# Town of Mammoth Lakes

## Advisory Design Panel Staff Report

<b>Date:</b>	February 14, 2019	<b>File No.:</b>	Major Design Review (DR) 18-006
<b>Place:</b>	Town & County Conference Room, 2 <sup>nd</sup> Floor Minaret Village Shopping Center Mammoth Lakes, CA 93546	<b>Project:</b>	Yotelpad
<b>Time:</b>	After 2:00 p.m.	<b>Location:</b>	6040, 6042, 6060 Minaret Road
<b>Appeal Status:</b>	Not Applicable	<b>General Plan:</b>	North Village Specific Plan (NVSP)
<b>Applicant / Owner:</b>	RePlay Destinations - Chris Heinrich / One Mammoth, LLC	<b>Specific Plan:</b>	North Village Specific Plan (NVSP)
<b>Environmental Review:</b>	Conformance review with the existing North Village Specific Plan Environmental Impact Report	<b>Zoning:</b>	North Village Specific Plan (NVSP)

**TITLE:** Yotelpad Design Review

## SD REFERENCE NOTES

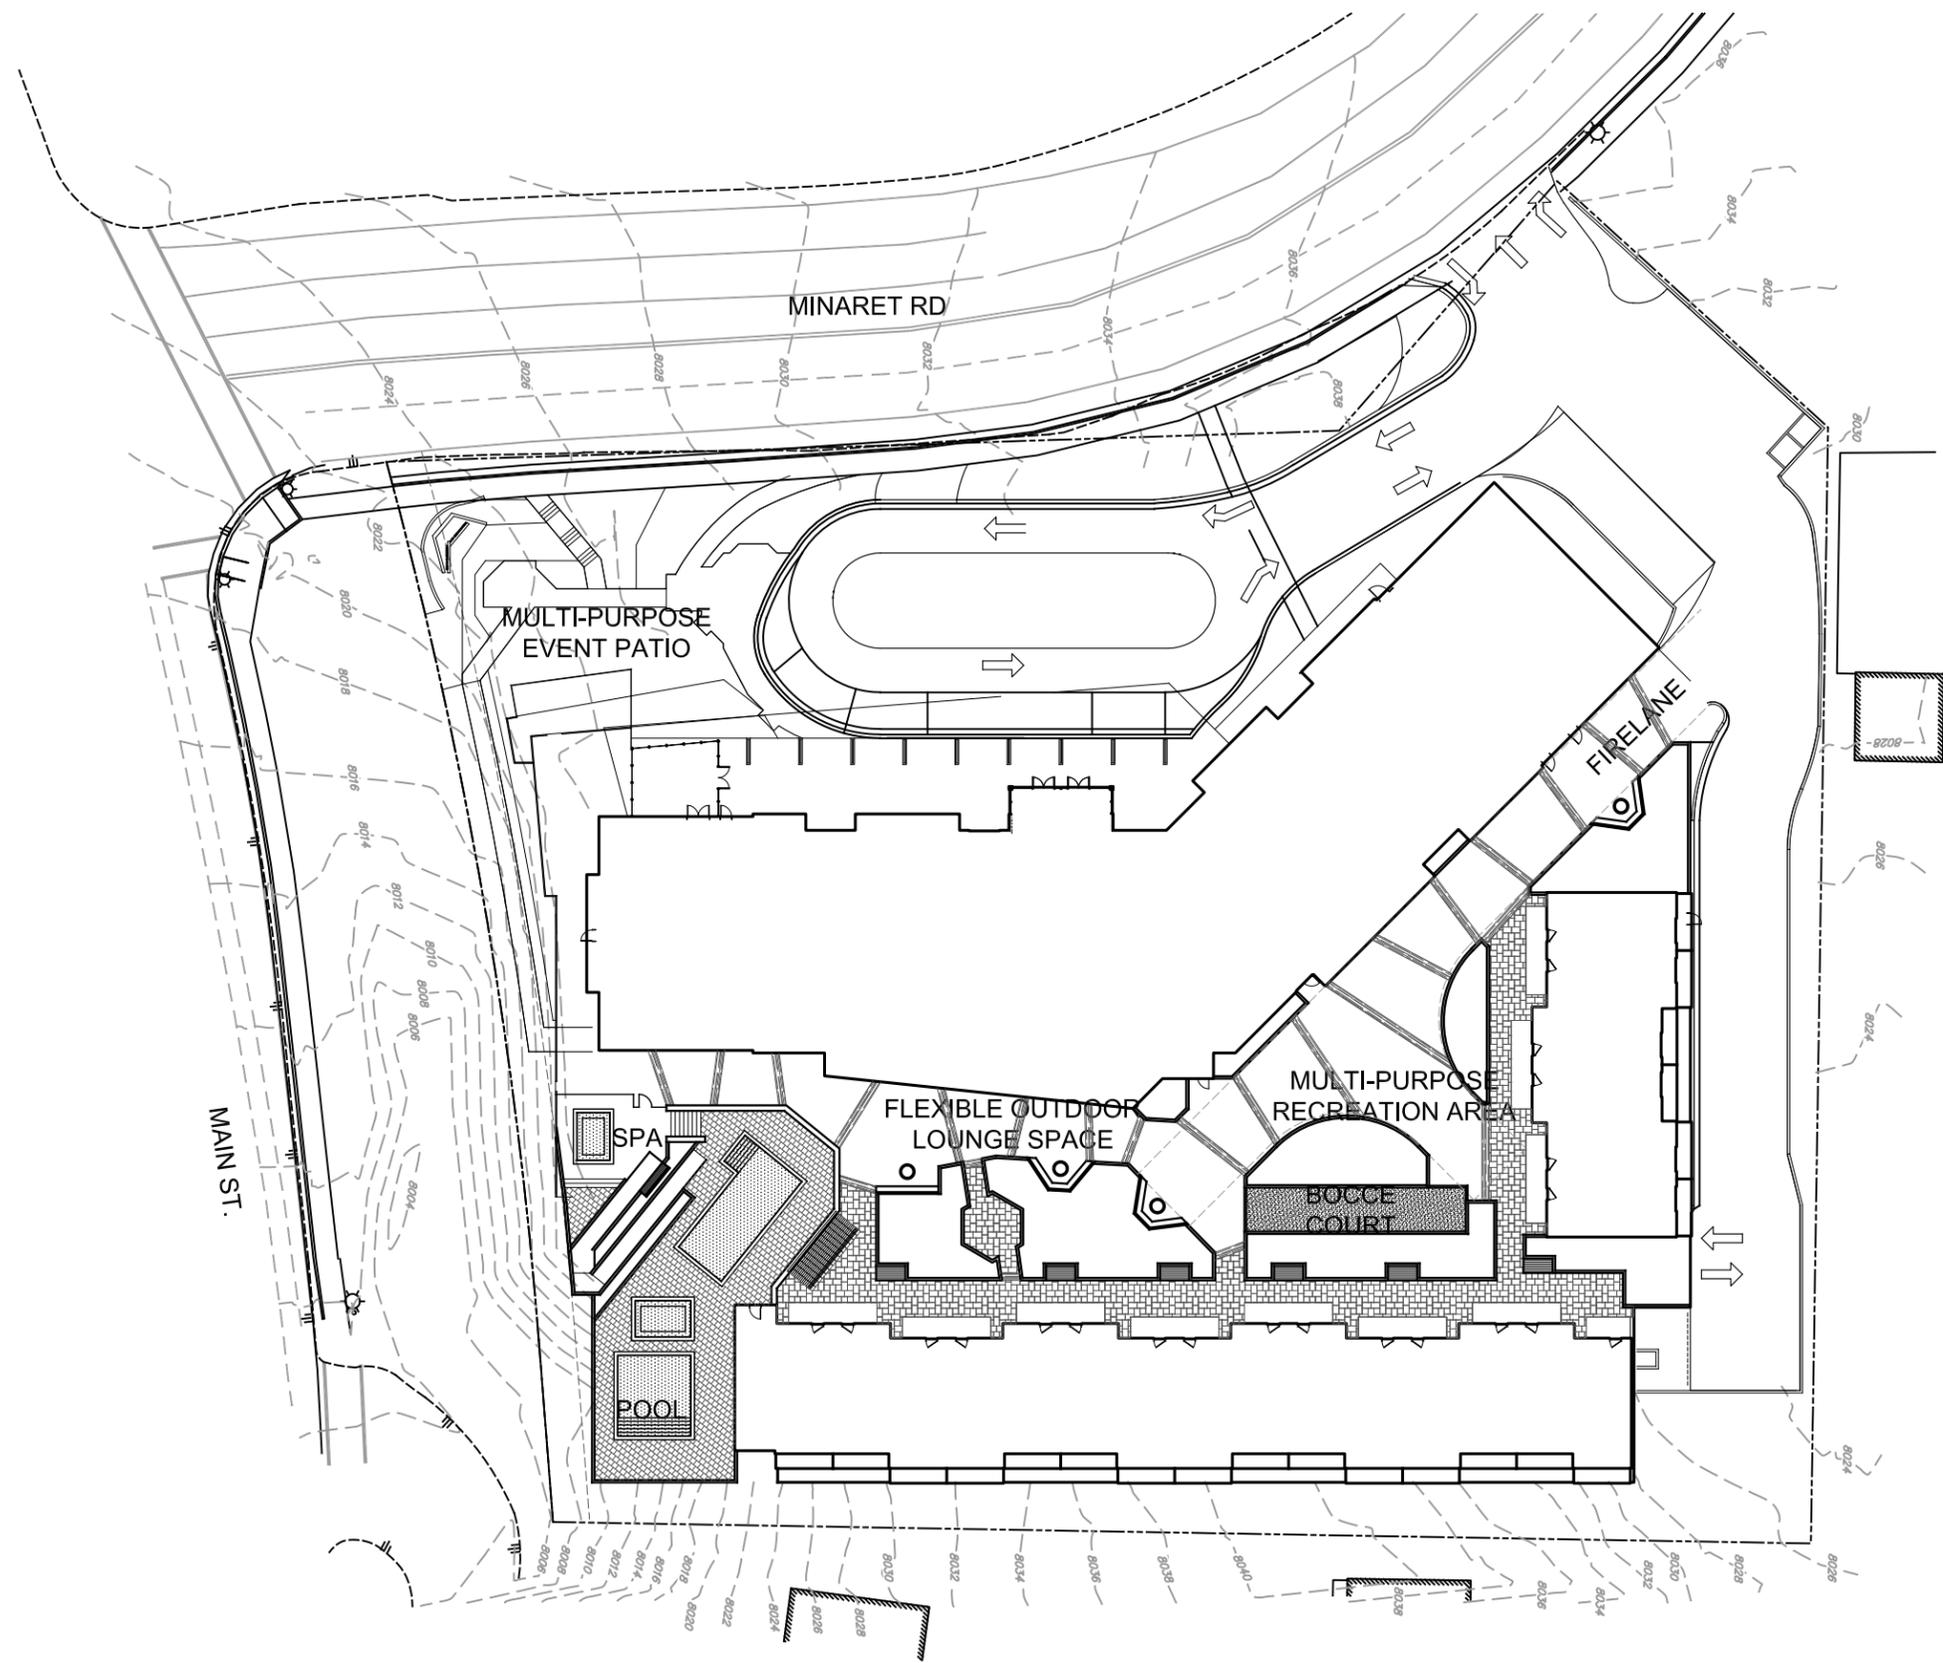
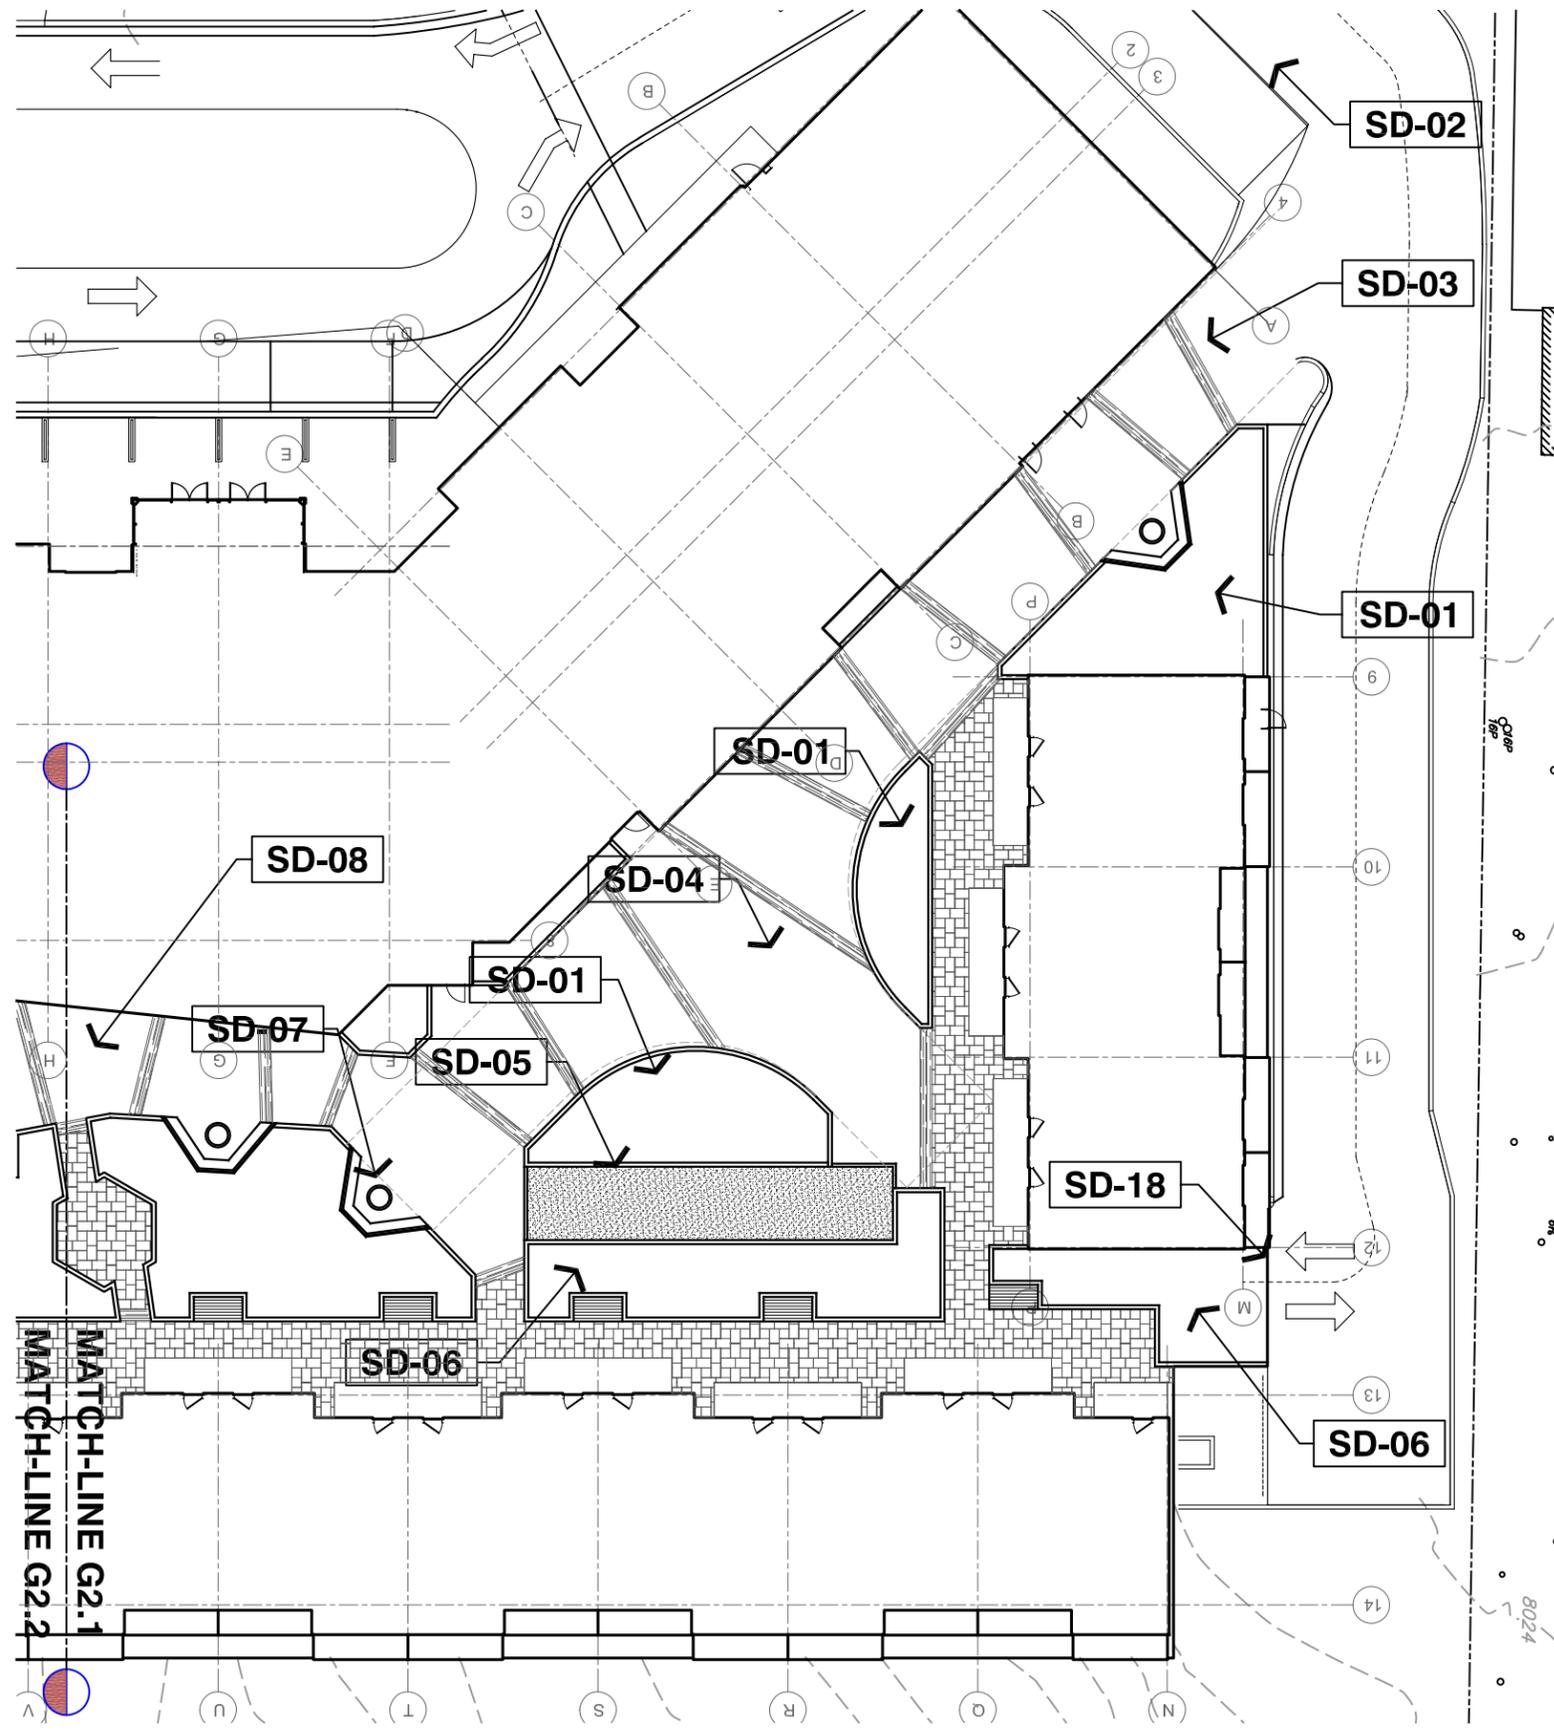
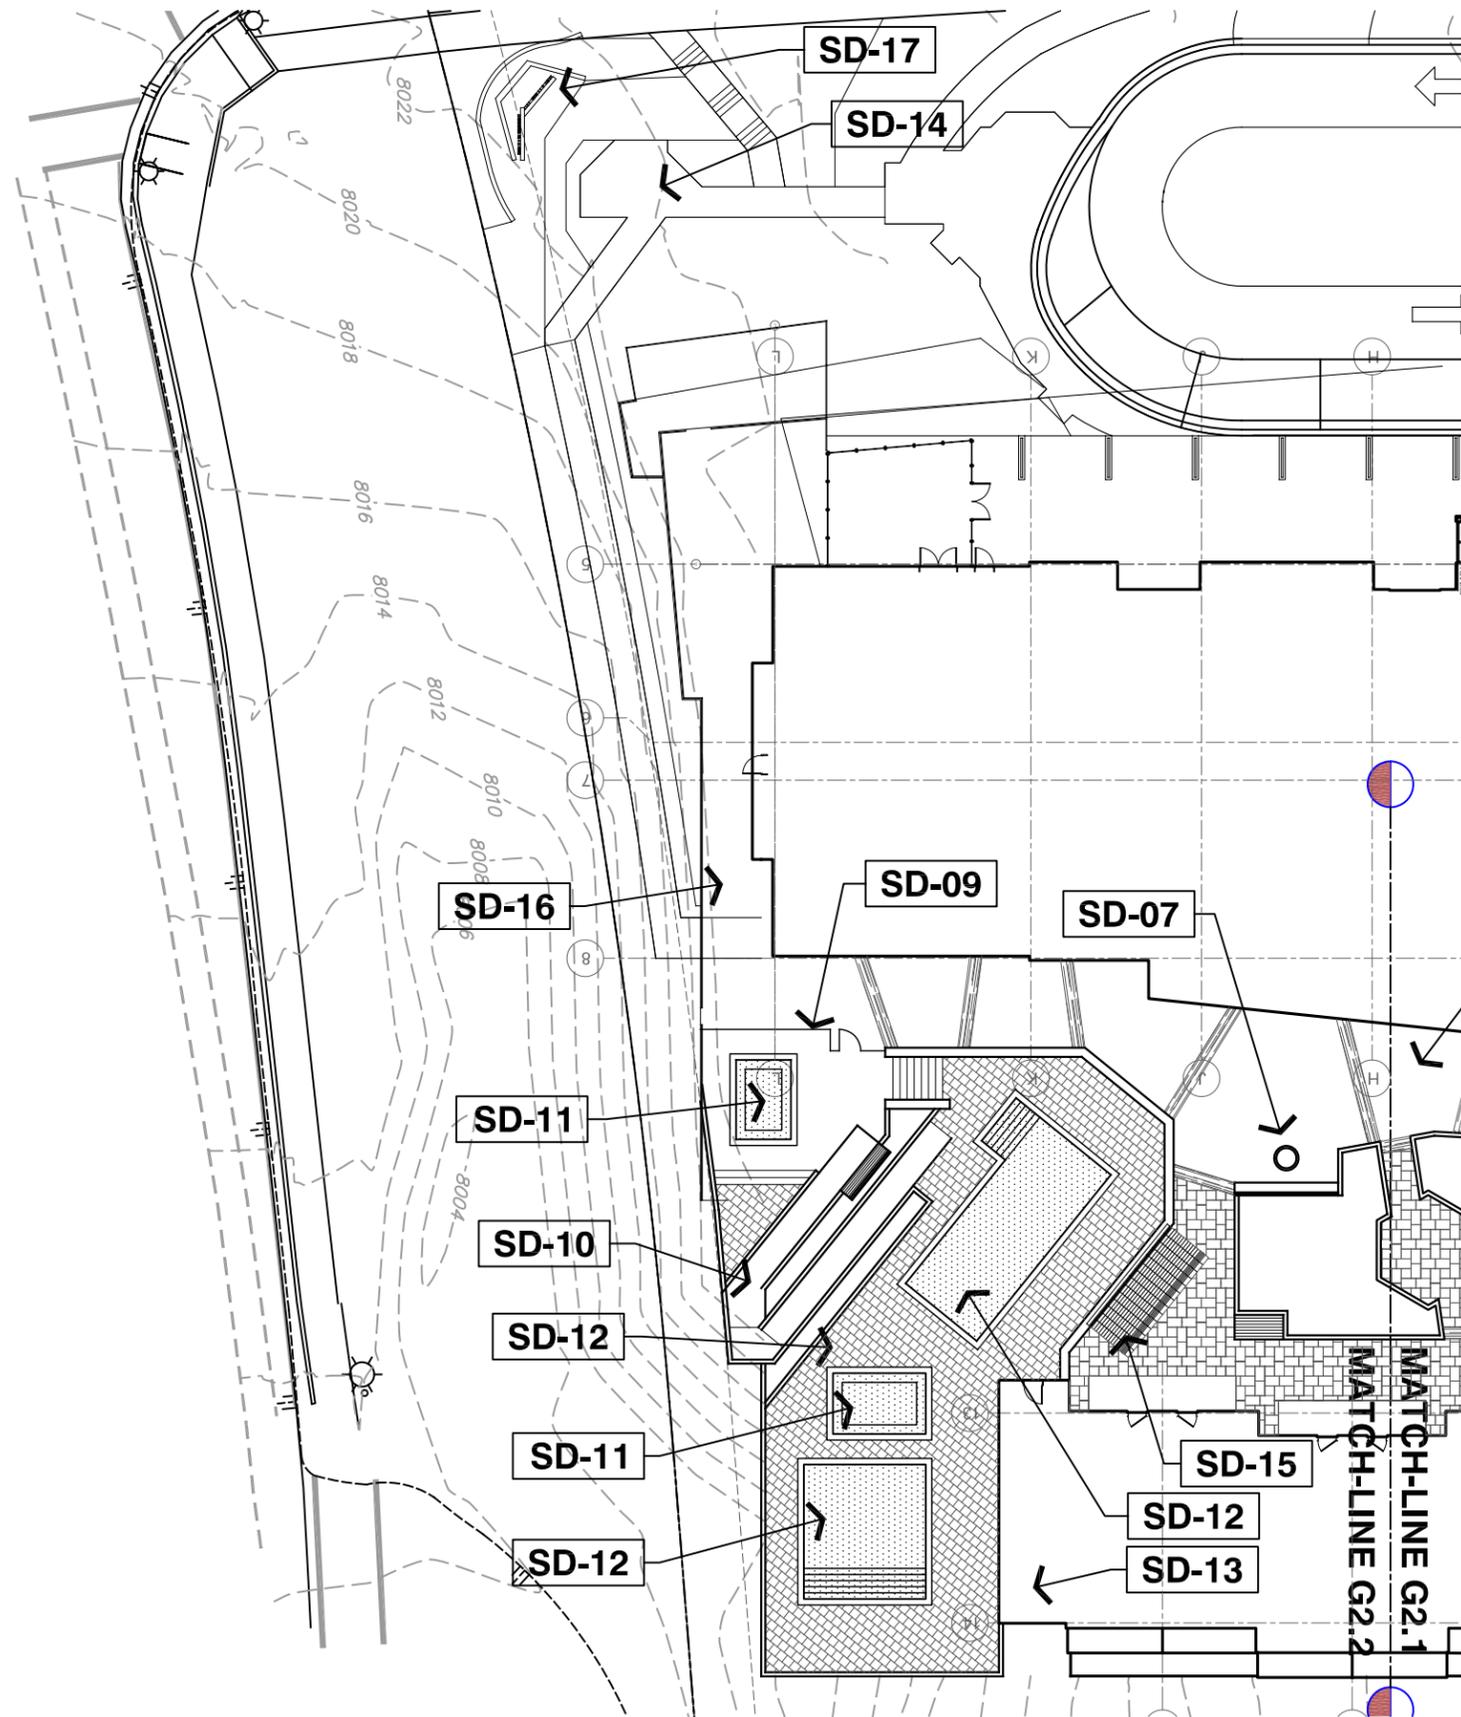
1. Pedestrian circulation is an issue and the project, as designed, is not consistent with the North Village Design Guidelines related to pedestrian connectivity. The front parking area impedes pedestrian connectivity to the Village and the visual of the parking lot and adjacent sidewalk as you turn from Main Street and Minaret Road appears as a "sidewalk in the middle of a freeway." The pedestrian area on the corner will be limited to summer use only and will be oftentimes windy.

2. The southwest corner of the site is the most visible location in Town and to use it as a parking lot is a loss. Consideration should be given to developing that corner with hotel guest uses (i.e., lobby area or restaurant space) to animate that corner and add visual interest and provide a buffer between the street and the rest of the project.

- Response:
    - The SW Corner has been re-designed to address pedestrian connectivity (Refer to Drawing F.2 & H.1) to the sidewalk along Minaret and to the crosswalk on the corner of Minaret and Mainstreet.

- Response:
    - The SW Corner has been re-designed to animate the corner by re-focusing the restaurant patios (Refer to Drawing F.1, F.2 & H.1).
    - The arrival valet area has been greatly reduced in size and all parking has been eliminated. The arrival valet area has also screened with landscaping, landscaping walls, etc. (refer to drawings G.4 and F.1)
